Culebrinas River Flood Control Project

**Prepared by Beverly Yoshioka
U.S. Fish and Wildlife Service
Boqueron Field Office**

November 1999

Culebrinas River Flood Control Project

Photo 1. Coloso diversion dam from the upstream side. Note that the opening is very narrow and topped by a road.

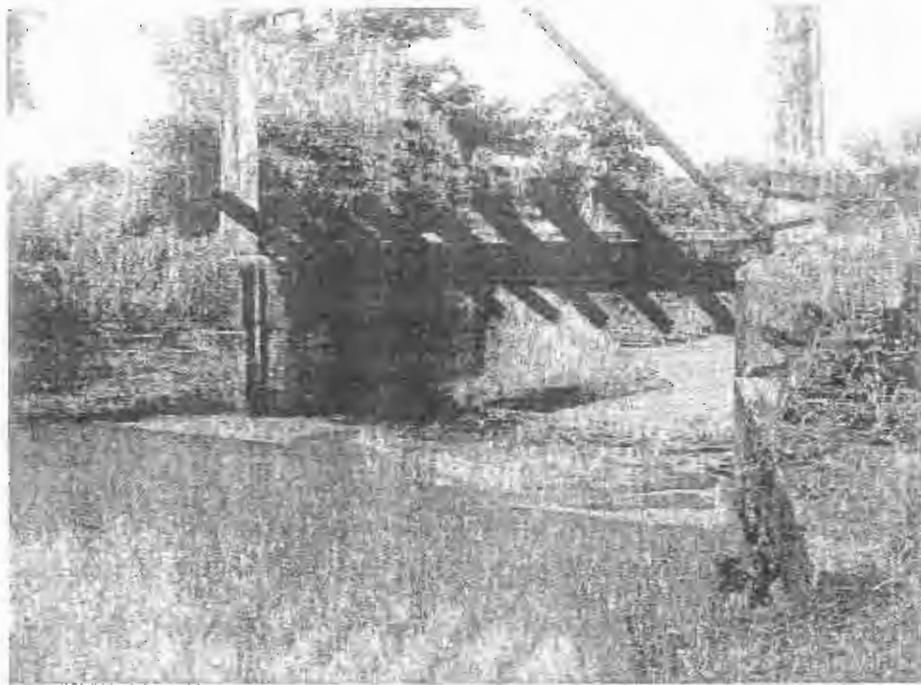
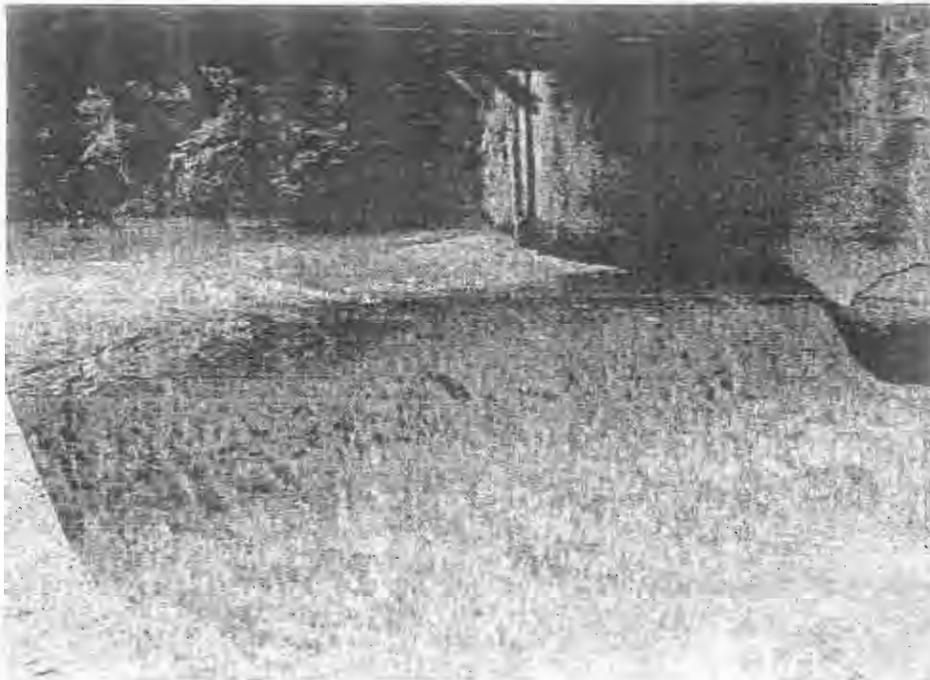
The river has no major impoundments, but does have a small low head dam (Photos 1 and 2) built in the early part of the century to provide a water diversion for the Coloso Sugar Mill. This diversion is still used to provide process water for the mill. In 1998, the Puerto Rico Aqueducts and Sewers Authority (PRASA) along with the Commonwealth Infrastructure Agency (AFI) developed a surface water intake for potable water using the impoundment from this dam. The dam is located several hundred meters upstream of PR-2, and the pump house is located on an elevated stand next to the diversion dam (presumably above the 100 year flood stage). The raw water is currently pumped up to the Aguadilla treatment plant, but AFI is considering the creation of an off-river reservoir/ sedimentation lake near the damsite to supply additional firm yield and reduce the very high sediment load in the raw water extracted from the river. Because of its narrow design, it is likely that the existing dam serves as a constriction creating overflow into the floodplain above PR-2 during flood stage.

The dam acts as a partial barrier for fish and shrimp migration upstream, and juvenile shrimp can generally be seen migrating upstream on the cement bulkhead of the weir in the wetted zone above the water flow (Photo 3). Native fish (approximately 6 species) and shrimp (as many as 14 species) are compulsory migrators, requiring a portion of their life cycles in estuarine or marine waters. At least six species of shrimps are large enough to be fished for human consumption, one species reaching very large sizes (Photo 4). Most of these species are also likely to occur in Caño Madre Vieja along with estuarine fish such as snook, tarpon, mullet, mojarra, and jacks; and crustaceans such as blue crabs and land crabs. Fishermen of the area

Figure 3. Original Alternative 2 from Section 205 Reconnaissance Report, 1991.

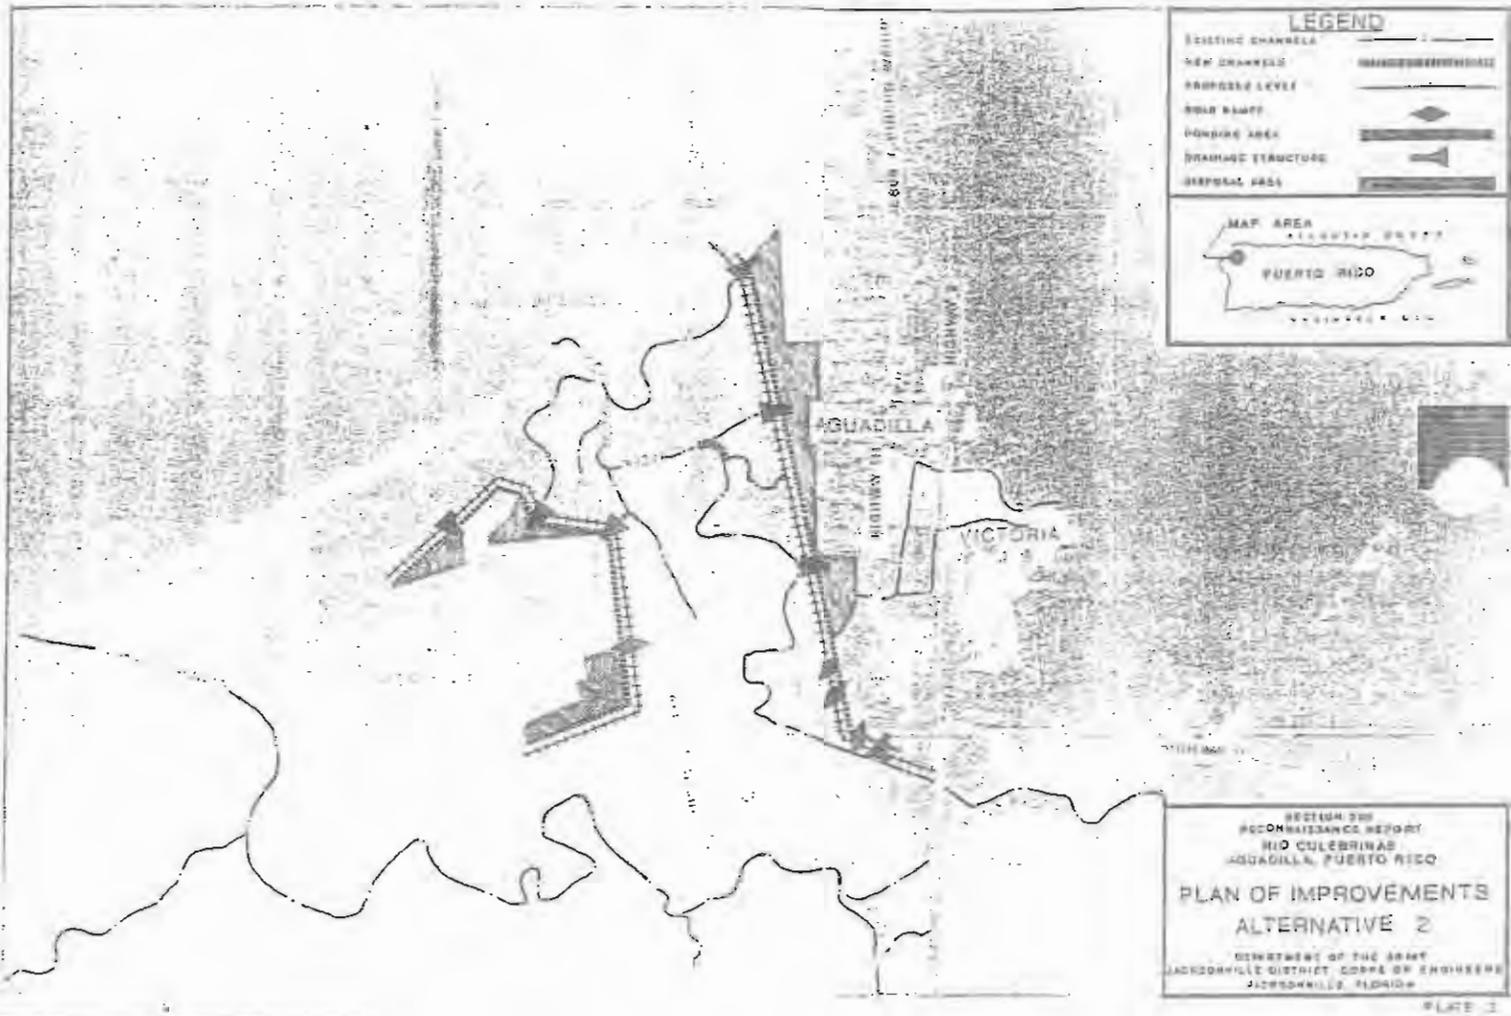
The original version of the two-levee alternative (Figure 3) included a flood ring levee immediately adjacent to the south, east and north sides of Espinar community. The variation to include the church could still be used within this alternative. That alternative would have impinged on the mangrove channel immediately adjacent to the northeast part of Espinar community, but would have remained south of the back-berm herbaceous and forested wetlands and Coastal Barrier Unit PR-75 and it would have avoided impacts to the sedge dominated wetlands south of the mangroves. The mangroves that would be impacted could be mitigated by relocating the portion of the channel to be impacted slightly eastward and replanting mangroves.
